**JOINT REGIONAL PLANNING PANEL
(Southern)**

JRPP No	2016STH019
DA Number	298-2016
Local Government Area	Queanbeyan-Palerang Regional Council
Proposed Development	Demolition of two classrooms and construction of three storey distance education centre
Street Address	42 Surveyor Street, Queanbeyan
Applicant/Owner	Department of Public Works / Department of Education
Number of Submissions	None
Regional Development Criteria (Schedule 4A of the Act)	Crown development with a capital investment value of more than \$5 million
List of All Relevant s79C(1)(a) Matters	<ul style="list-style-type: none"> • State Environmental Planning Policy No. 55 – Contaminated Land Management • State Environmental Planning Policy (Infrastructure) 2007 • Queanbeyan Local Environmental Plan 2012 • Queanbeyan Development Control Plan
List all documents submitted with this report for the panel's consideration	<ul style="list-style-type: none"> • Architectural Plans as amended – Prepared by Thorn Architecture • Traffic Impact Assessment – Prepared by GTA Consultants • Acoustic Assessment Report – Prepared by Rudds Consulting Engineers • Stormwater report and calculations – Prepared by EFWW consulting engineers •

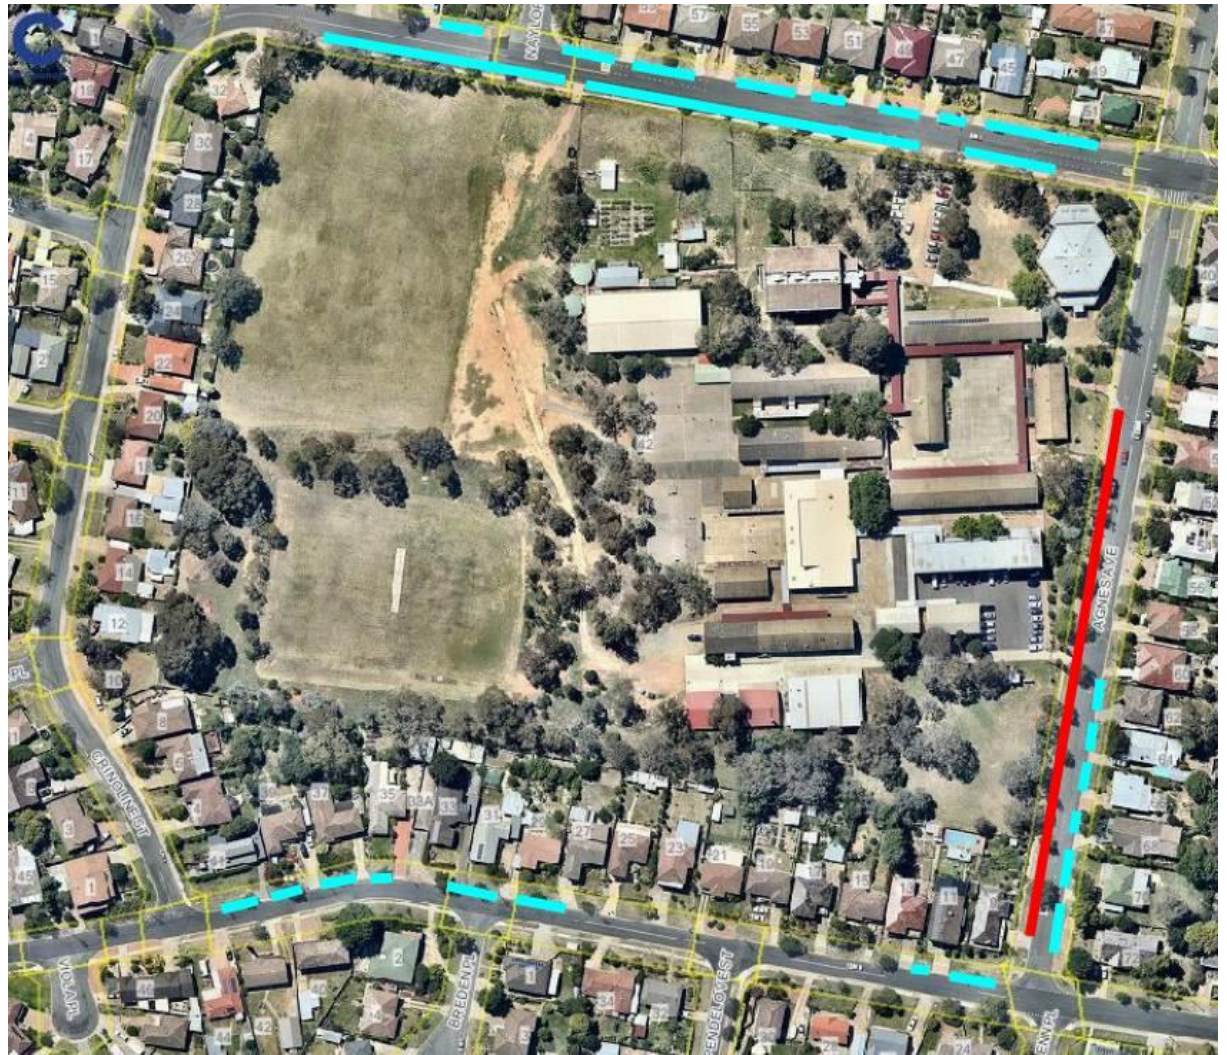
It is considered that the proposed development is likely to result in a significant adverse impact on the surrounding residential streets, particularly Agnes Avenue and that this impact has not been adequately addressed in either the Statement of Environmental Effects or the traffic impact assessment. The traffic impact assessment concludes that the existing street network is capable of absorbing the additional parking required, however this position is not supported. The report has undertaken an empirical assessment indicating a parking demand of 55 spaces on a 'typical' day and up to 85 spaces on occasion. At 55 spaces the report estimates approximately 360m of kerbside would be required to accommodate parking.

Figure 12 – location of proposed waste area. The proposed location does not appear to permit a waste collection vehicle to enter and exit the site in a forwards direction.

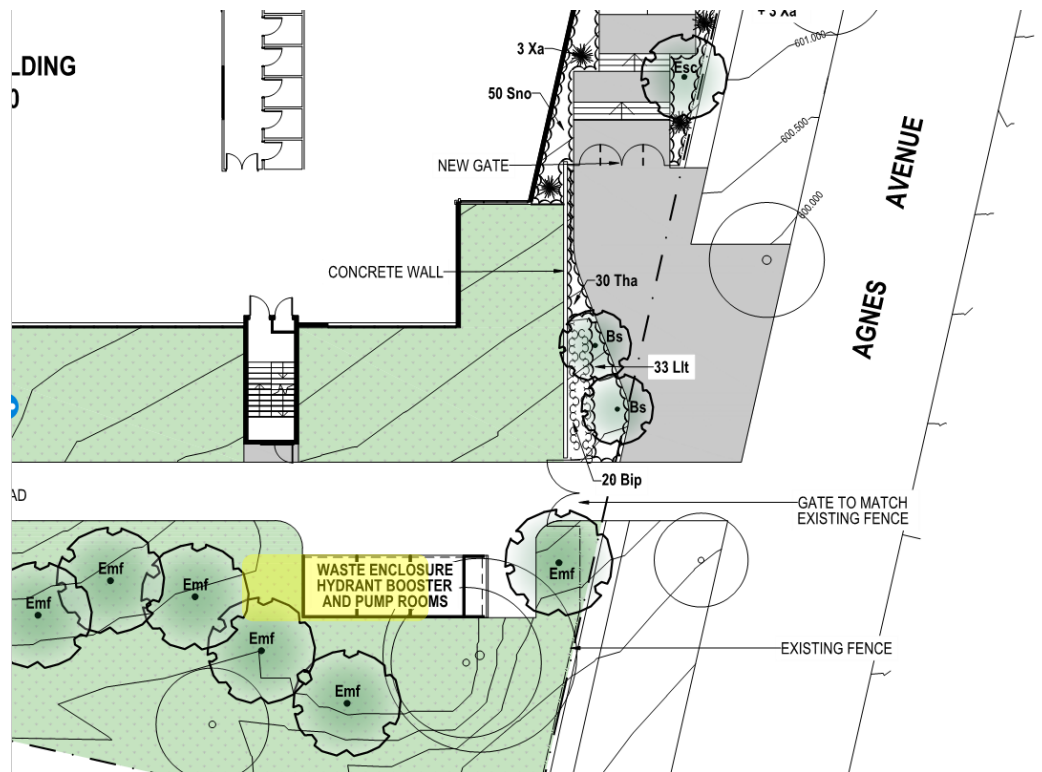
A waste management area is proposed to the south of the site adjacent to the Agnes Avenue entrance and includes separate hoppers for recyclable waste and general waste. There is concern that the waste management area does not permit a waste collection vehicle to enter and exit in a forwards direction. A waste management plan has not been provided with the application. A condition is proposed requiring a waste management plan to be prepared detailing the location and proposed collection of waste. The plan should include details of how collection vehicles can enter and exit the site in a forwards direction.

Prior to commencement an amended site plan is to be submitted to and endorsed by Council, clearly demonstrating that a suitable waste management area can be located on the site and that a front-lift loading collection vehicle can enter and exit the site in a forwards direction to collect waste from the waste management area.
